CITY OF PHILADELPHIA

Office of Innovation and Technology
(on behalf of
Philadelphia Fire Department)

REQUEST FOR INFORMATION

Rugged Mobile Devices

MDT mounted in Spartan Fire Apparatus

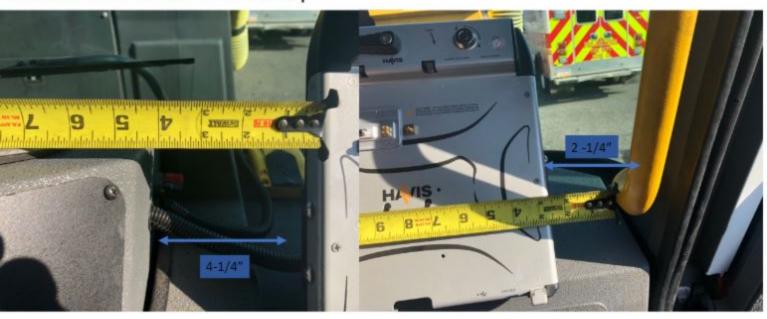
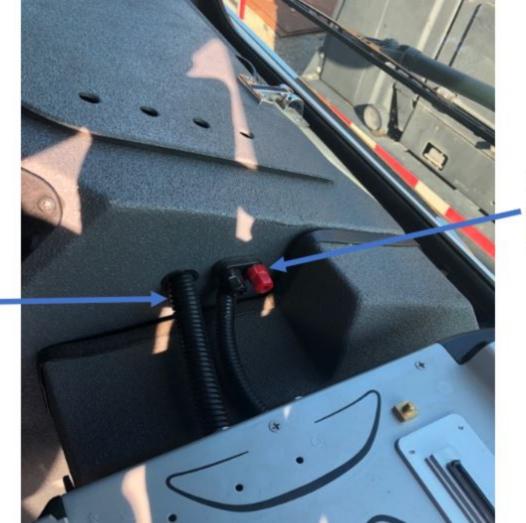
2.	Section I. Anticipated Solution Requirements	Where is the 12.75" width restriction come from? If space is a concern, is Philadelphia willing to provide pictures of the limited area?	The size restraint came from the maximum size that could fit in one of the vehicles with the least amount of usable dash space. See attached pictures for reference.

View from officers seat. Dock pulled up to allow Officer to see info. Dock is sitting flat to allow driver to see.

# Dash Space

1"

20"

Dock to windshield

3-1/4"

Distance with Dock up

DOCK OVERHANG
